Grand Bay Sub. Amenities Area

On-Site Sewage Disposal

Plastic Chamber Plan

RE: GRAND BAY SUBDIVISION, AMENITIES AREA ON-SITE SEWAGE DISPOSAL SYSTEM & REPAIR AREA, PROPERTY DESCRIPTION # 22126, GRAND BAY DRIVE, IREDELL COUNTY, NC.

Grand Bay Amenities Area

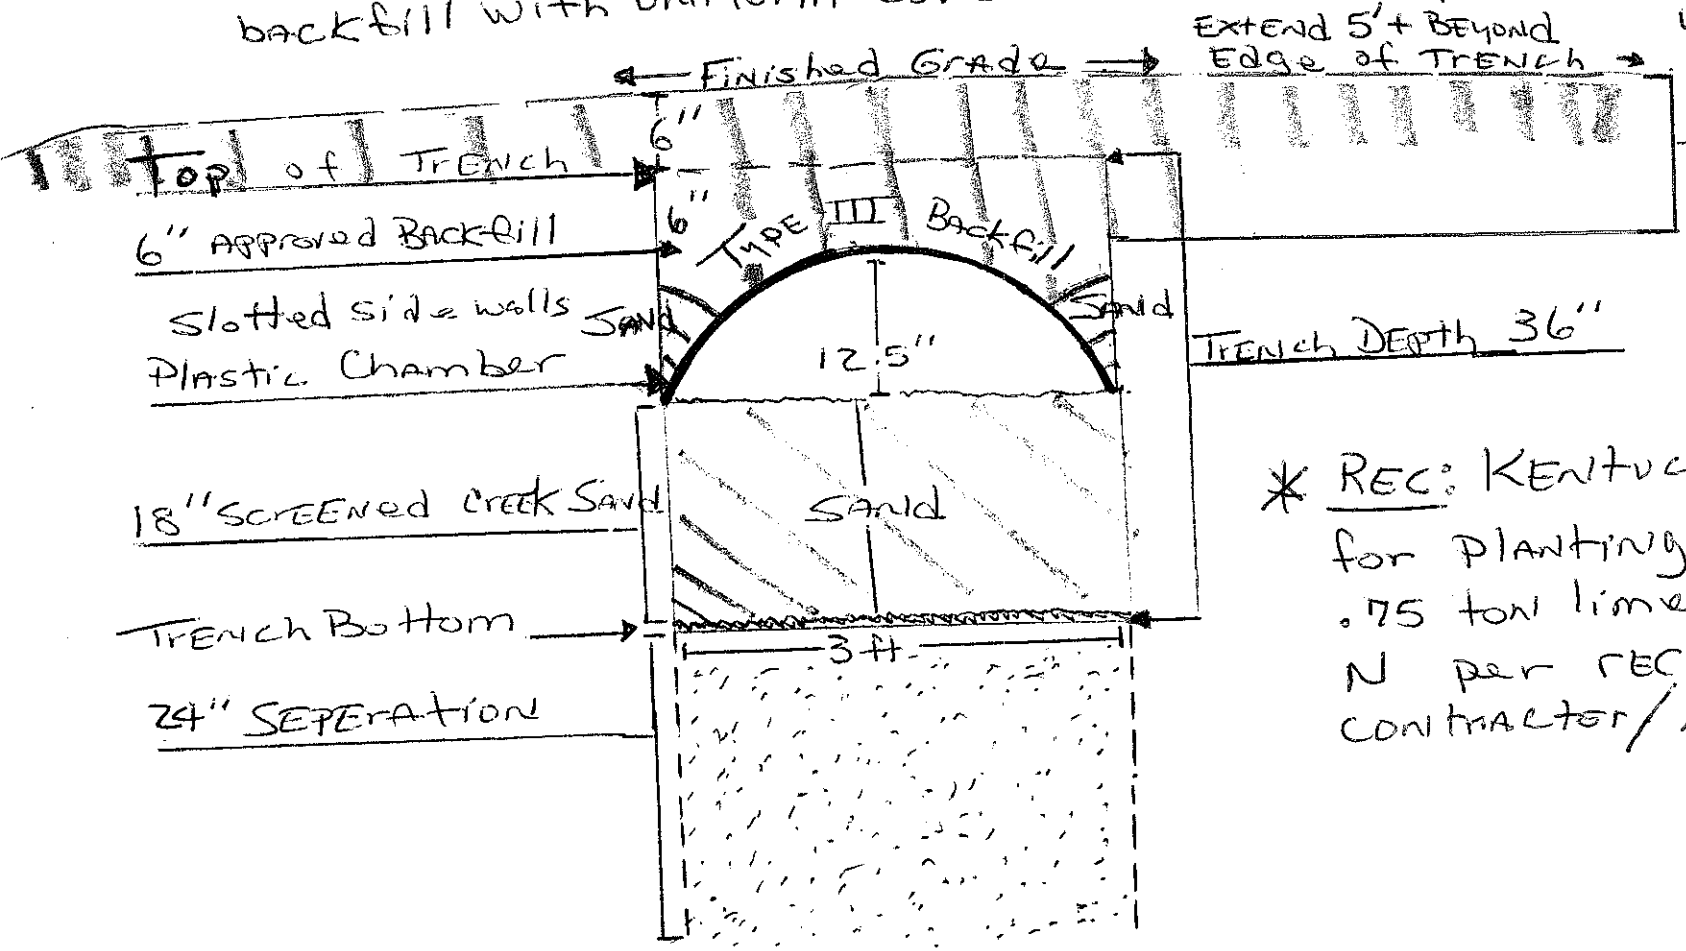
** **Trench Profile:** 36" depth, 36" wide, Excavate to ~~36~~ 60" then backfill with 18" of screened creek sand. Place chambers on top of sand. Backfill slotted chambers sidewalls with sand. Then backfill with uniform cover approved Type III material.

Grand Bay Amenities Area

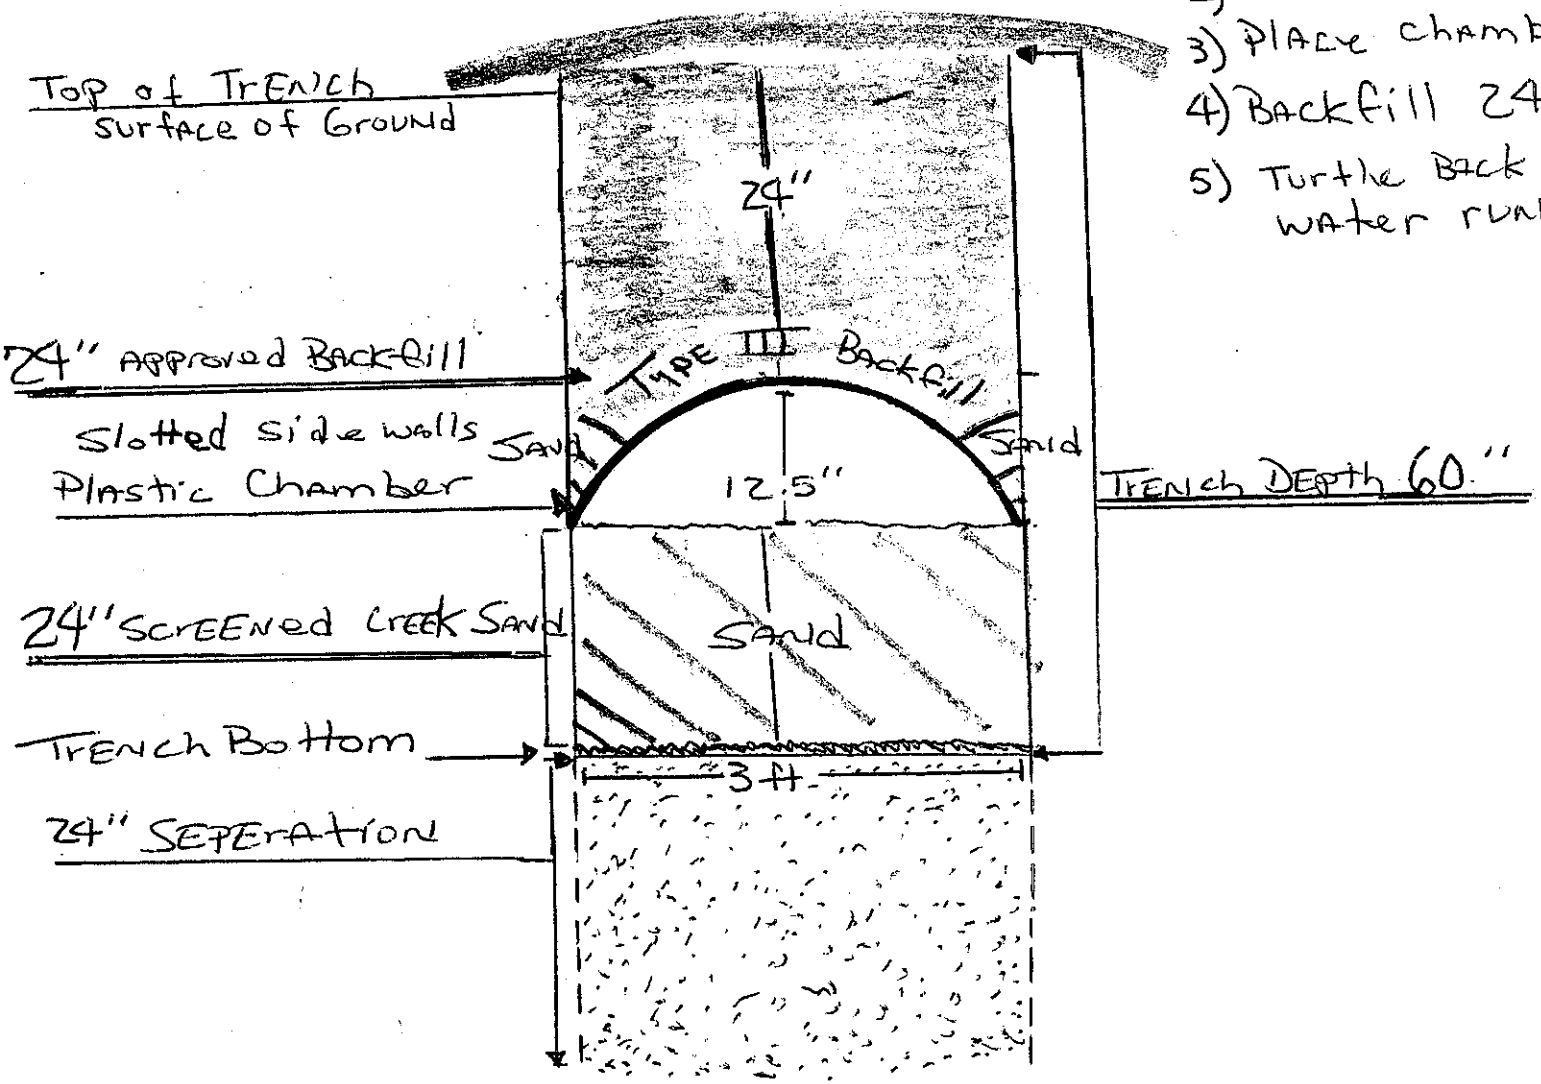
*Trench Profile:

1) Excavate Trench to 60"
2) Place 24" Sand into Trench
3) Place chamber on Top of Sand
4) Backfill 24" approved material
5) Turtle Back slope for uniform water run-off.
